**City of Portland, Maine – Building or Use Permit Application** 389 Congress Street, 04101, Tel: (207) 874-8703, FAX: 874-8716

BUILDING PERMIT REPORT

REASON FOR PERMIT: To Amend Permit # 000138/01 Skylights

PROPOSAL FOR ADDITIONAL WORK  
TO THE CROUTER COTTAGE on GREAT  
DIAMOND ISLAND (Weymouth St.)  
+ Spring Ave

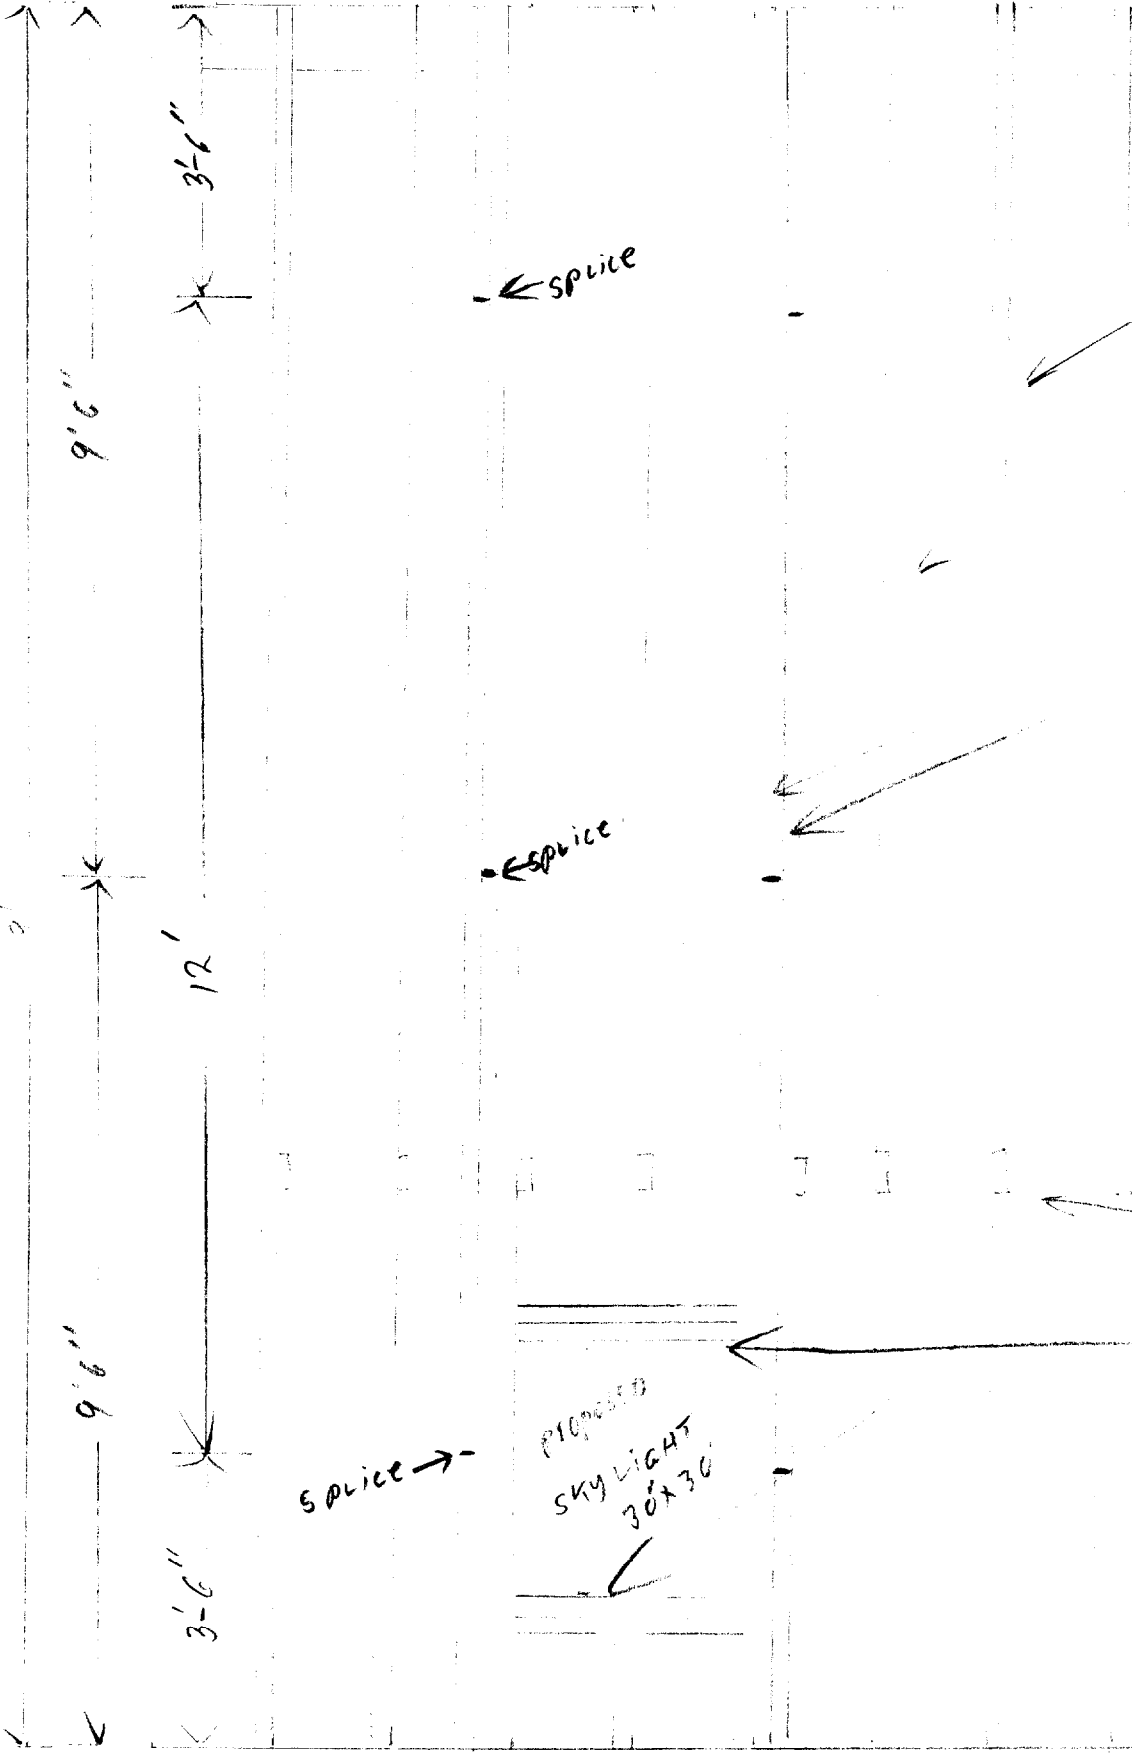
- \* 33. Bridging shall comply with Section 2305.16.
- \* 34. Glass and glazing shall meet the requirements of Chapter 24 of the building code. (Safety Glazing Section 2406.0) *SKYLIGHTS 2405.0 SCREEN ARE REQUIRED*

- \* 37. *This permit is being issued with the understanding that the rafters are to remain - IF THIS IS NOT THE CASE THE RAFTER SHALL BE DOUBLED WITH HEADERS*
